Work Order ID 96689

Item Name: Crosstube Fwd

DRAWING NO. D206-667-143	TITLE CROSSTUBE ASS'Y (206L HIGH FWD)	REV. C	DART AEROSPACE LTD ENGINEERING ORDER		D.E.O. NO. D206-667-143-C-1	SHEET NO. SHEET 1 OF 1	SCALE NTS
DRAWN 9	CHECKED ASS	MFG. APPR. [Signature]	APPROVED [Signature]		DE APPR. [Signature]		
DATE 11.07.15	DATE 11.07.20	DATE 11.07.21	DATE 11/07/21		DATE 11.07.21

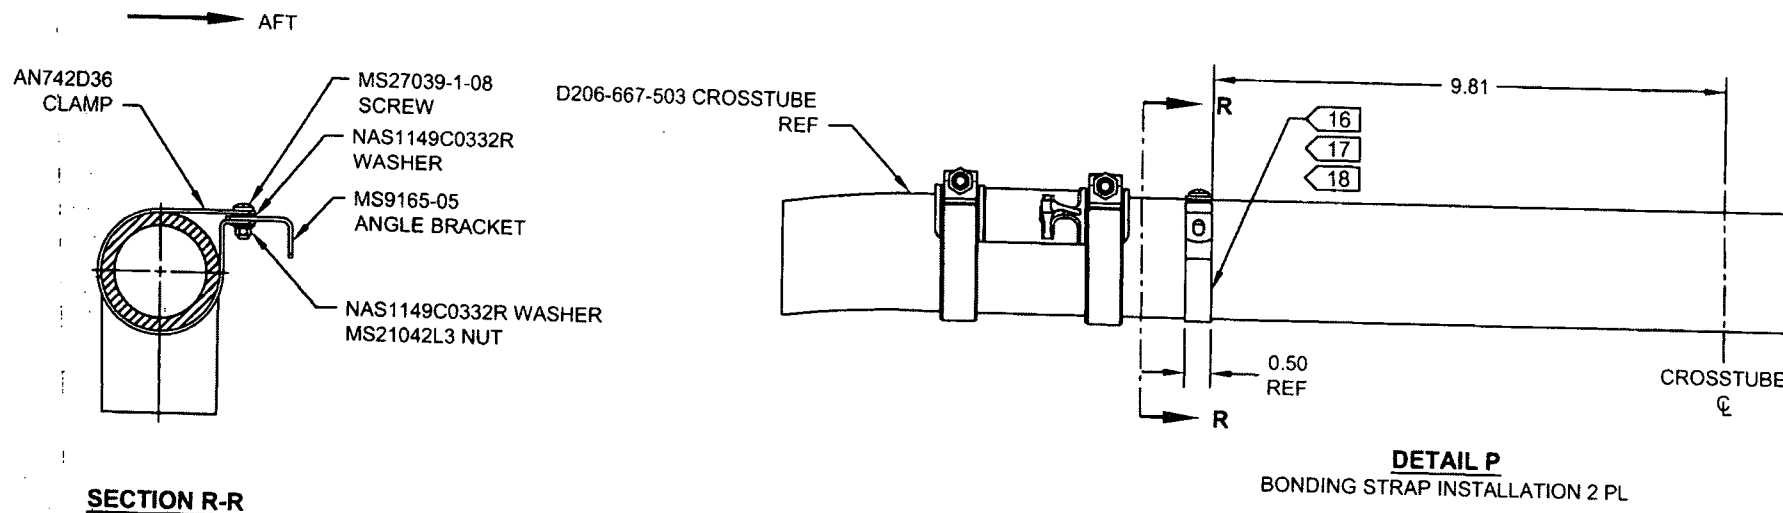
ADD ELECTRICAL GROUNDING STRAP

- 16) MASK AREA UNDER CLAMP PRIOR TO PAINTING
- 17) SEAL EDGES WHERE AN742D36 CLAMP MEETS WITH THE CROSSTUBE USING SIKAFLEX-241/-291 OR MIL-S-8802 CLASS B2 OR PROSEAL 890 SEALANT
- 18) PERFORM RESISTANCE CHECK TO ENSURE MAX RESISTANCE IS 10 MILLIOHMS
